MINERALS PROGRAM INSPECTION REPORT PHONE: (303) 866-3567

MINE NAME:		MINE/PROSPECTING ID#:	MINERAL:	COUNTY:
County Line Pit		M-1987-016	Sand and gravel	Lincoln
INSPECTION TYPE:		WEATHER: Clear	INSP. DATE:	INSP. TIME:
Surety Release Inspection			April 22, 2025	12:30
OPERATOR:		OPERATOR REPRESENTATIVE:	TYPE OF OPERATION:	
Lincoln County			110c - Construction Limited Impact	
REASON FOR INSPECTION:		BOND CALCULATION TYPE:	BOND AMOUNT:	
Surety Release Requested			\$0.00	
DATE OF COMPLAINT:		POST INSP. CONTACTS:	JOINT INSP. AGENCY:	
NA		None	None	
INSPECTOR(S):	INSPECTOR'S SIGNATURE:		SIGNATURE DAT	E :
Ben Hammar			April 30, 2025	
	6	Mmar

Photo 1: Example bouindary marker and bare spots.

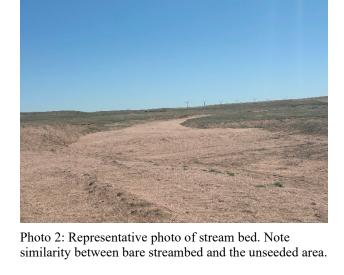
Overall, the grading of the site appears to be adequate and adheres to the 3:1 slope requirement of the rangeland post-mining land use. Vegetation appears to be well established, with the significant exception of a large area outside of the stream bed which was stripped to act as a product stockpile. At the time of inspection this area has not been reseeded. With the exception of the mentioned area, the site appears to be trending towards complete cover and being generally in-line with the agricultural character of the surrounding land. The streambed appears to be reclaimed to an adequate degree and disturbance is minimal. Unfortunately given the significant area of bare grass the Division will be denying the request to release this site at this time. Once the problem area has been adequately reseeded and evidence of consistent growth is shown the site may be reevaluated.
